AP - 121

From:	Chavez, Carl J, EMNRD
To:	"Heidi Jones"
Cc:	Gregory J. McCartney P. E. (gjmccartney@marathonpetroleum.com); Polak, Tiffany, EMNRD
Subject:	AP-121 (Formerly Conoco AP-117/GW-054) Marathon Petroleum Company- Wingate Gas Plant McKinley Co. (Secs. 9 – 10 & 15 – 17 15N-7W): MARATHON PETROLEUM CORPORATION MARATHON WINGATE FACILITY BENZENE INVESTIGATION REPORT JULY 17, 2020
Date:	Monday, September 21, 2020 1:52:00 PM

From: Chavez, Carl J, EMNRD
Sent: Friday, November 22, 2019 9:45 AM
To: 'Moore, John'; 'Moore, Brian'
Cc: 'McCartney, Gregory J.'; Griswold, Jim, EMNRD; Wade, Gabriel, EMNRD
Subject: RE: Wingate Geoprobe Investigation WMW-2 Benzene Exceedance (AP-121) Work Plan

To:	Carl Chavez, Oil Conservation Division (OCD)
From:	John Moore, Marathon Petroleum Corporation (Marathon)
cc:	Greg McCartney, Marathon; Heidi Jones, Trihydro
Date:	November 1, 2019
Re:	Wingate Facility – WMW-2 Benzene Exceedance

Figure 1
Proposed borehole locations

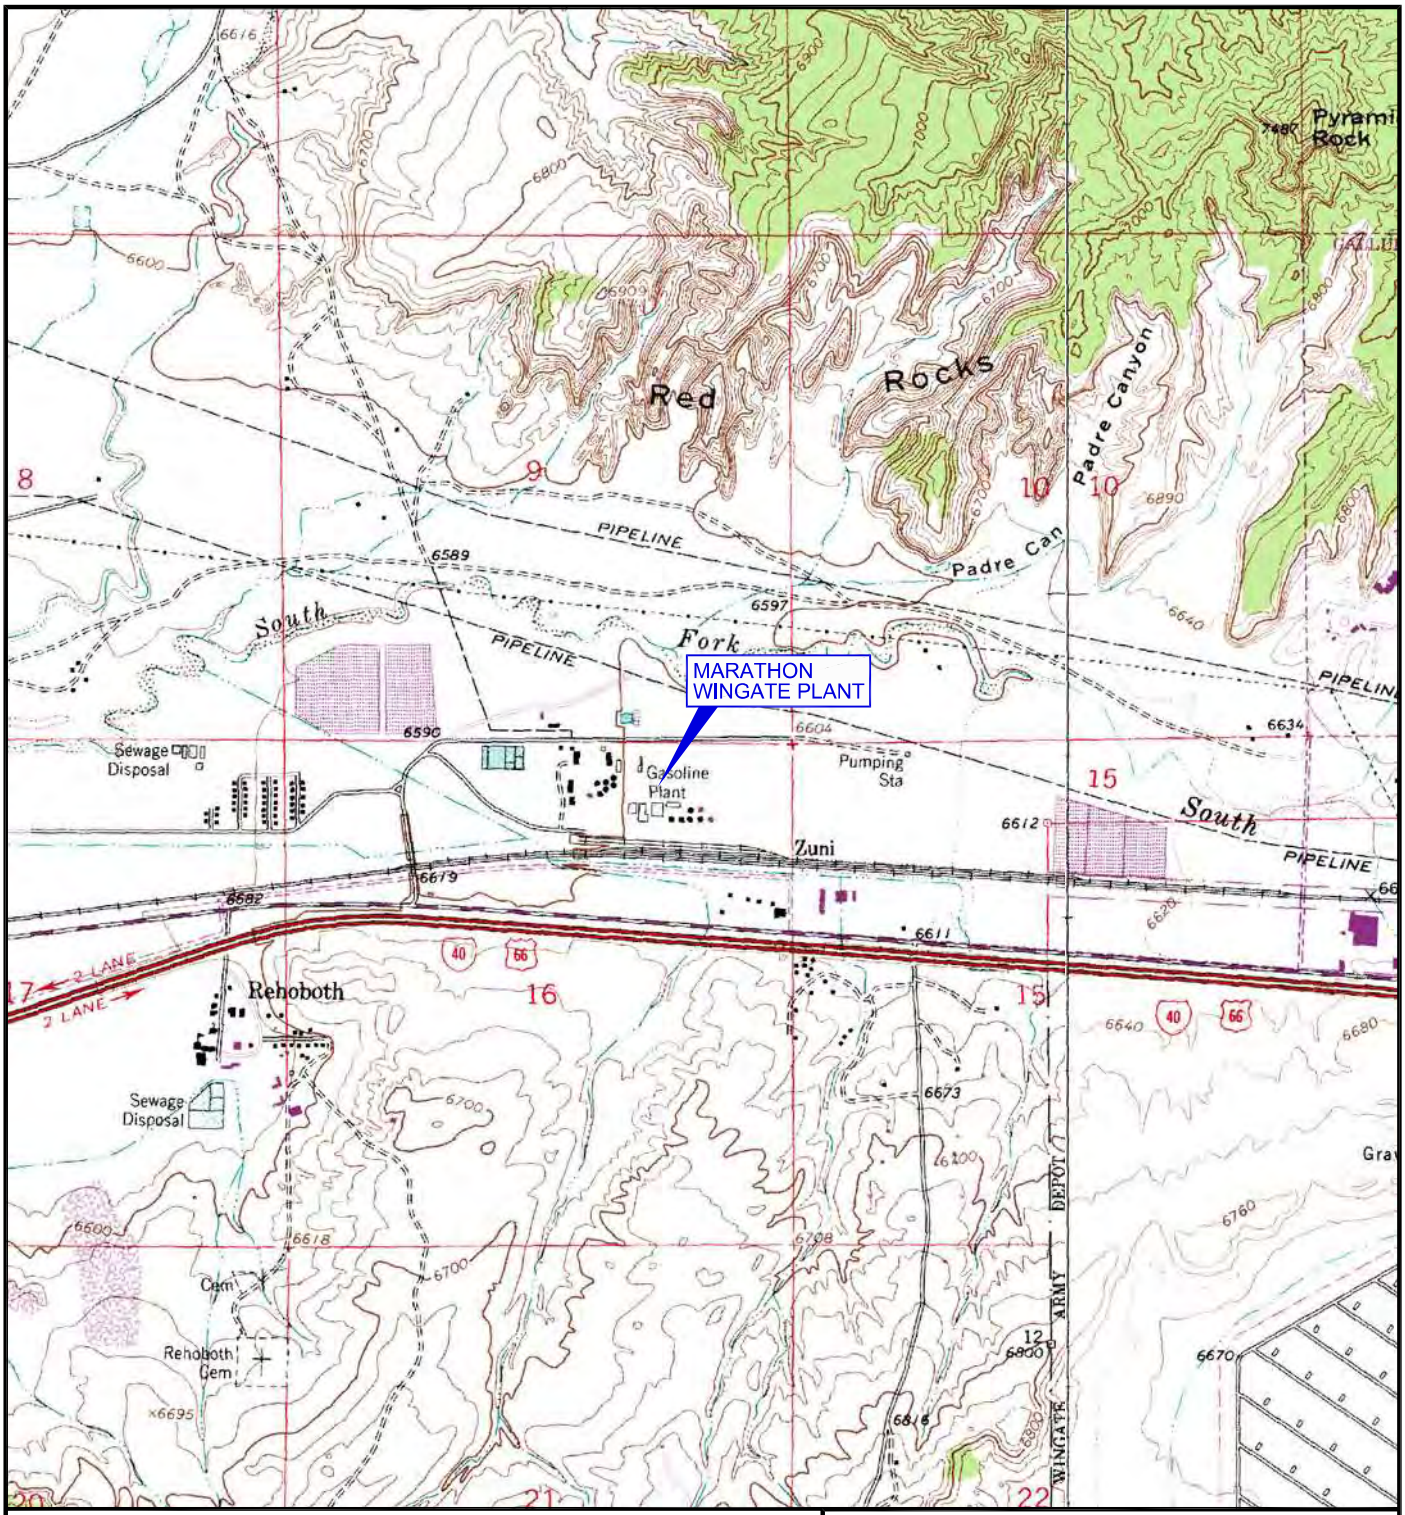
1) Adhere to EPA QA/QC and DQOs during the environmental field investigation, sampling and analytical lab work.
2) Work plan Section c.iv.5: One environmental soil sample at BH-1, BH-2, BH-3, BH-4 and BH-5 from above the water table is required with 8260 Method lab analysis is required.
3) Based on step out approach, i.e., BHs 6 – 11, based on field PID > 1 ppm results per BH, continued step-out to complete horizontal characterization of contamination is required (see OCD "Recommendations" section below).
4) More information on the ponds and their proximity or intersection with potential GW contamination observed at WMW-2 is needed.
5) Provide a work schedule to OCD within 30 days from the date of this message.

1) The map with proposed BHs does not have a scale; however, all BHs appear to be within Marathon Property.
2) Marathon mentions WMW-7 was installed into an artesian saturated sand zone below clay with head indicative of artesian condition. There appears to be a shallow water table aquifer or perched aquifer present at the facility. Perhaps the water table pinches out in the vicinity of WMW-7.
3) WMW-2 appears to be at or near the benzene source area.
4) No soil sampling is proposed.
5) All of the proposed BHs appear to be on Marathon Property.
